Bristol-Myers Squibb Company

DOCKET NO.: 030-05222
CONTROL NO.: 124288
LICENSE NO.: 29-00139-02

RESPONSE TO NRC REQUEST FOR ADDITIONAL INFORMATION - LICENSE #29-00139-02

This is in reference to your application dated February 18, 1997 requesting to renew Nuclear Regulatory Commission License No. 29-00139-02. In order to continue our review, we need the following additional information:

DR.: R.G.	E. R. SQUIBB & SONS, INC.				C.A.R.	
DATE: 9-27-88	NEW BRUNSWICK, N. J.				P.N.: 124-196	
SCALE: NTS	MODIFICATION TO STACK SAMPLING SYS.				D.M.	
CH.					DRAWING NUMBER	
APPD.	NO.	REVISIONS	DATE	BY	APPD.	SK 9907
APPD.						
APPD.						
APPD.

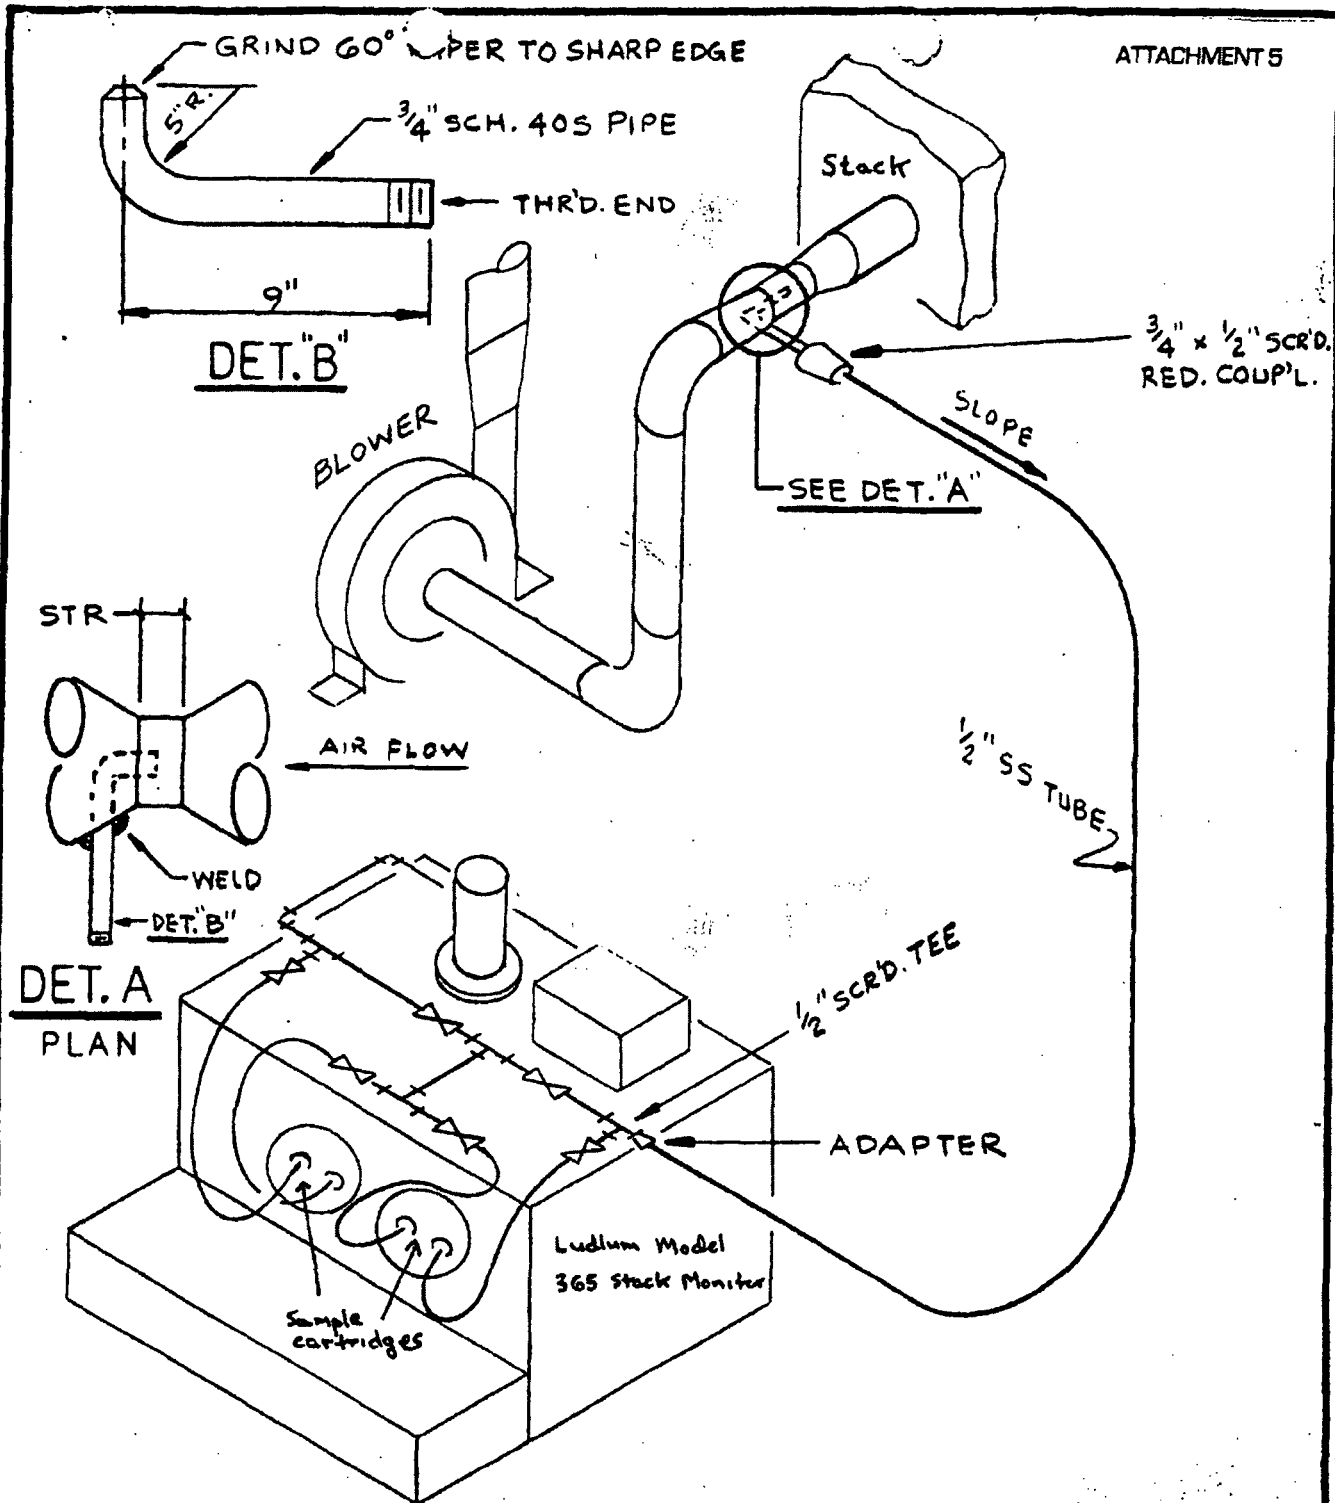
Engineered features that are in place to preclude large releases of radioactivity are summarized in Item #9 of the February 18, 1997 license renewal application. Further detail is given in Question #21 above. These redundant features are always in operation and do not need to be activated in the event of an abnormal occurrence. Specific pieces of equipment (i.e. filter trains, holding tanks) are controlled manually.

Question #23:

Provide a schematic drawing showing the location of the sample cartridge and the stack alarm detector. Paragraph #5 on page 1-8 states: "The radioactivity in the sampler is constantly measured by the stack alarm detector which will sound an alarm in the Health Physics operations area should the integrated activity representing the 24 hour effluent limit for I-131 as specified in Appendix B, Table II, Column I of 10 CFR 20 be exceeded." Provide specific details about the stack alarm detector, and specify whether the alarm setpoint(s) interact with the HVAC system.
